CITY OF ALBUQUERQUE

**RE: Industrial Water Engineering
Grading and Drainage Plan
Engineer's Stamp Date 12/13/17
Hydrology File: C16D006LL**

RE: Industrial Water Engineering G&D Plan Resubmittal (C16D006LL)

Drainage Easement Capacity

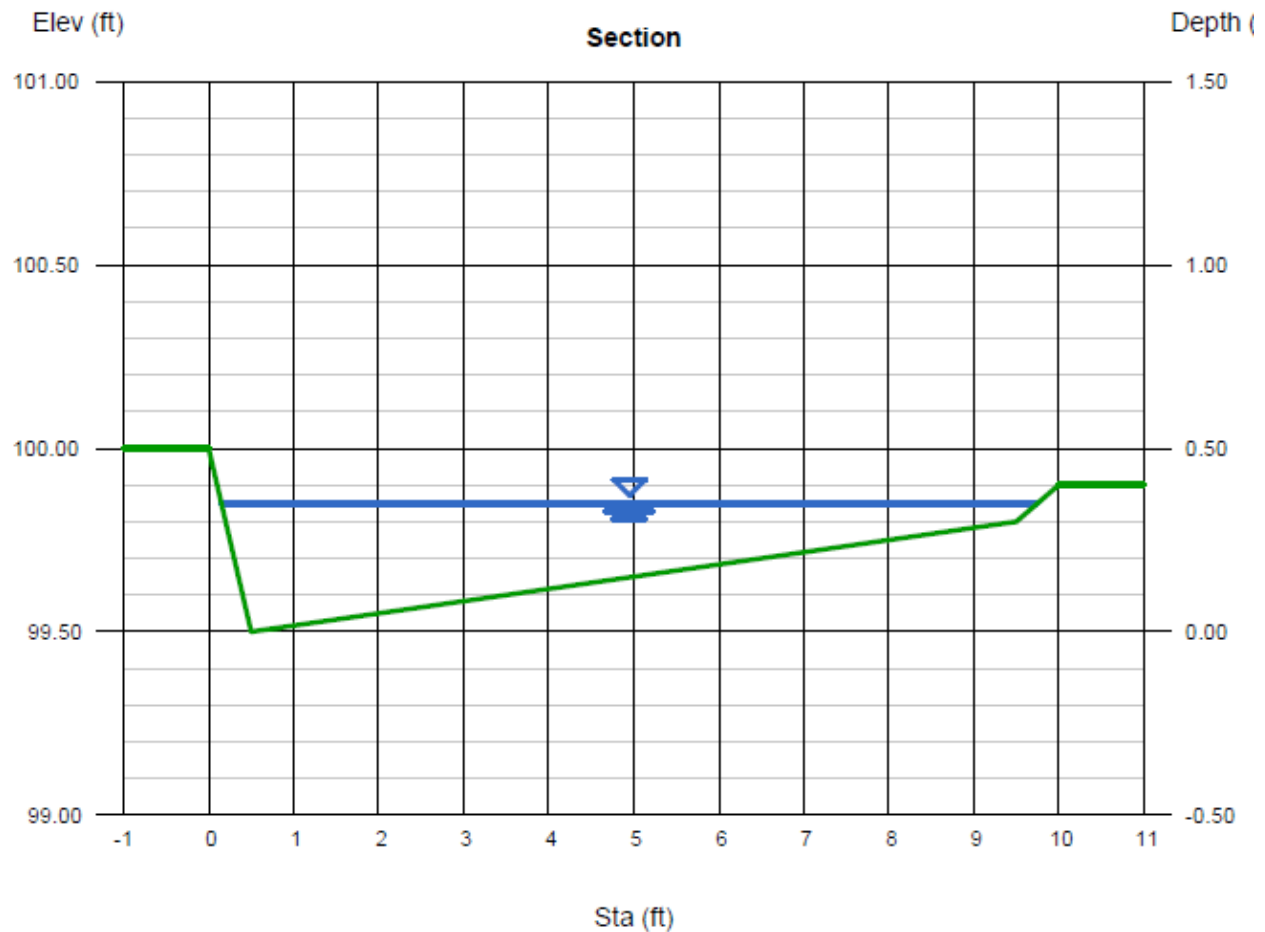
1. Pertinent text has been adjusted to 0.1'..
2. Top of pond, bottom of pond and volumes are called out on sheet CG-101.
3. ESC plan is completed and approved.
4. Draft of Private Facility Drainage Covenant for first flush ponds is provided for review.
5. Hydraulic capacity calculations for the existing sidewalk culvert and existing drainage channel downstream of the overflow from Pond P3 is provided.

We have also added a 0.1' high raised curb on the east edge of the west drainage easement to keep on-site first flush and off-site discharge separated. The off-site discharge passing through the property (6.72 cfs) is handled at a depth of 0.3' along the west curb (see channel calculations attached). The maximum capacity at a depth of 0.4' is 14.5 cfs.
